Item Name: Crosstube Turning Detail

DART AEROSPACE LTD	Work Order:	115330
Description: Crosstube Assembly (412 High Aft)	Part Number:	D412-664-243
Inspection Dwg: D412-664-243 Rev: E		Page 1 of 2

DRAWING NO. D412-664-243	TITLE CROSSTUBE ASS'Y (412 HI AFT)	REV. E	DART AEROSPACE LTD ENGINEERING ORDER		D.E.O. NO. D412-664-243-E-2	SHEET NO. SHEET 1 OF 1	SCALE NTS
DRAWN P	CHECKED AS	MFG. APPR. E	APPROVED MP		DE APPR. H		
DATE 11.09.07	DATE 11.09.19	DATE 11.09.19	DATE 11.09.19		DATE 11.09.19

DRAWING NO. D412-664-243	TITLE CROSSTUBE ASSEMBLY (412 HI AFT)	REV. E	DART AEROSPACE LTD ENGINEERING ORDER		D.E.O. NO. D412-664-243-E-4	SHEET NO. SHEET 1 OF 3	SCALE NTS
DRAWN 92	CHECKED A	MFG. APPR. A	APPROVED MP		DE APPR. MP		
DATE 12.08.21	DATE 12.08.30	DATE 12.08.30	DATE 12/8/30		DATE 12.08.30

**D412-664-243
ASSEMBLY DETAIL**

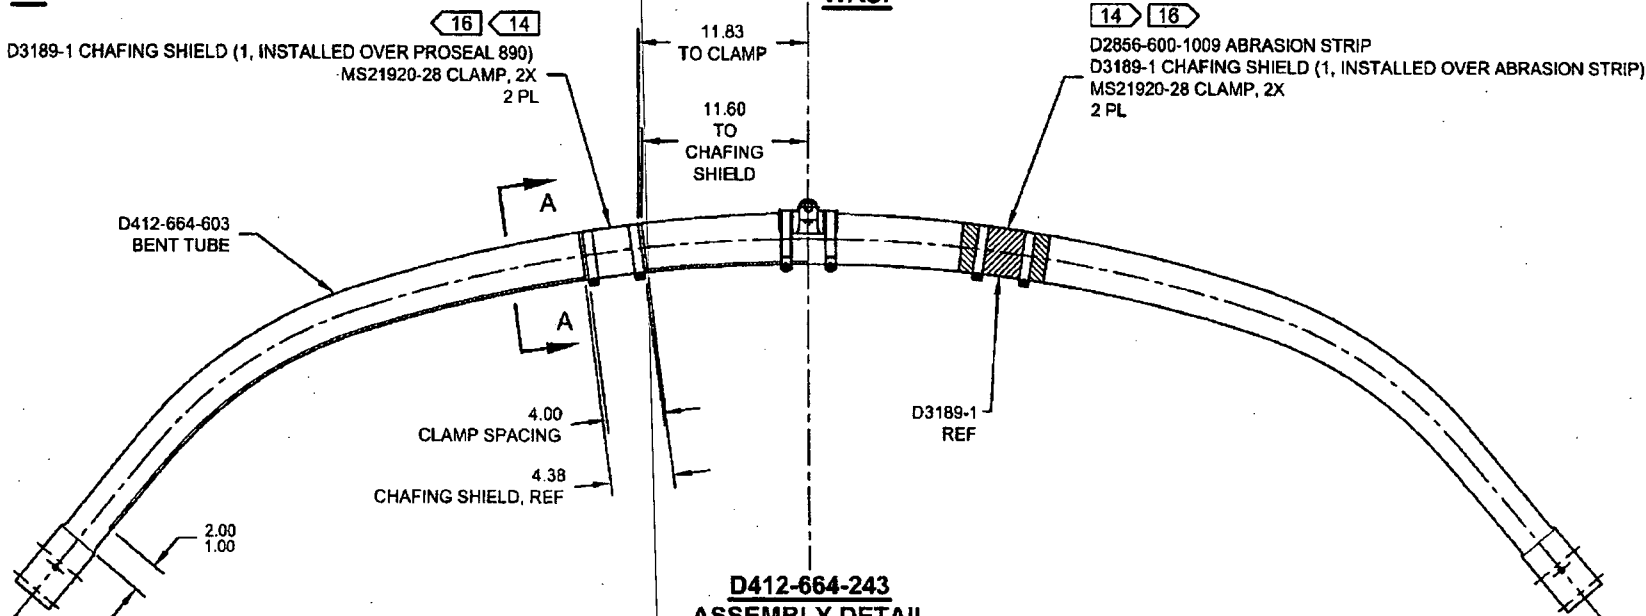
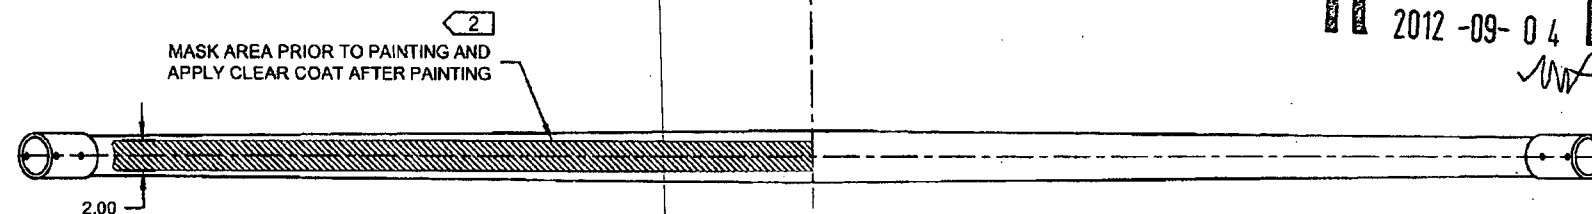
REMOVED ABRASION STRIP IN FAVOR OF A THIN LAYER OF PROSEAL 890. UPDATE INSTALLATION OF CHAFING SHIELDS AND REDUCE TORQUE TO 40-50 IN-LBS. THIS ENGINEERING ORDER SUPERCEDES DEO D412-664-243-E-1.

IS:

D3189-1 CHAFING SHIELD (1, INSTALLED OVER PROSEAL 890)
MS21920-28 CLAMP, 2X
2 PL

WAS:

D2856-600-1009 ABRASION STRIP
D3189-1 CHAFING SHIELD (1, INSTALLED OVER ABRASION STRIP)
MS21920-28 CLAMP, 2X
2 PL

SECTION A-A
CHAFING SHIELD DETAIL
VIEW ROTATED, NOT TO SCALE

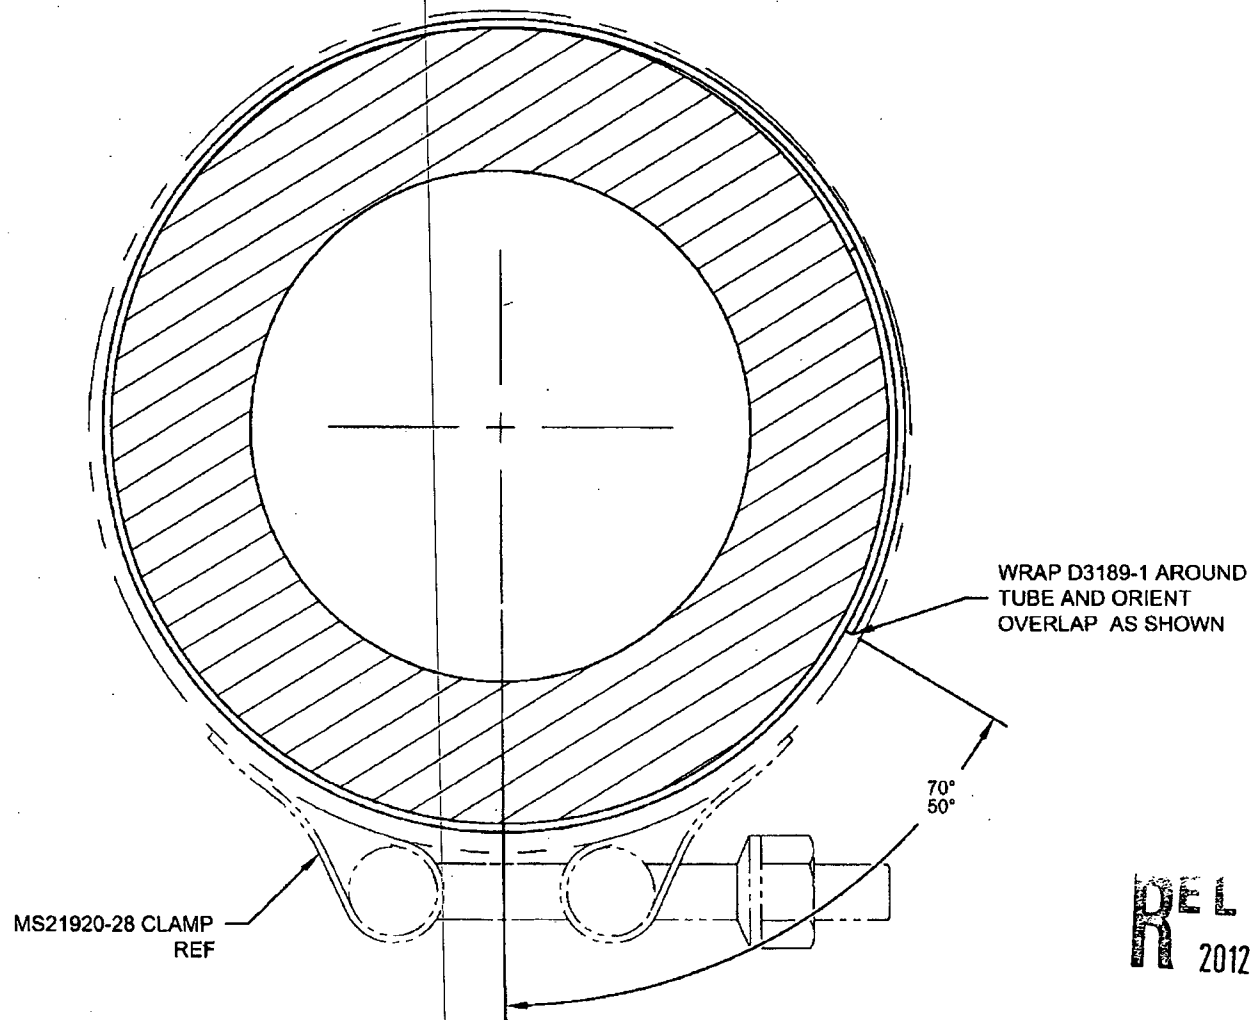
- 2) FINISH: CHEMICAL CONVERSION COAT PER DART QSI 005 4.1
PRIME INSIDE AND OUTSIDE PER DART QSI 005 4.2
MASK UNDERSIDE OF CROSSTUBE AS SHOWN (HATCHED AREA)
PAINT OUTSIDE PER DART QSI 005 4.2
AFTER PAINTING, APPLY CLEAR COAT ON HATCHED AREA
- 14) APPLY A THIN COAT OF PROSEAL 890 ON INSIDE CONCAVE SURFACE OF D3189-1 CHAFING SHIELD AND LET CURE PER MANUFACTURER'S INSTRUCTIONS. INSTALL PROSEALED D3189-1 CHAFING SHIELD ONTO CROSSTUBE BY APPLYING A THIN COAT OF PROSEAL 890 ONTO CROSSTUBE. BE SURE TO ELIMINATE ANY AIR GAPS.
- 16) TORQUE CLAMPS ON D2896-1 SUPPORT 80 TO 100 IN-LB. **TORQUE CLAMPS ON D3189-1 CHAFING SHIELD 40 TO 50 IN-LB.**
ENSURE AT LEAST 1.5 THREADS SHOWING IN SAFETY AND THAT NUT HAS NOT BOTTOMED-OUT AFTER TORQUING.
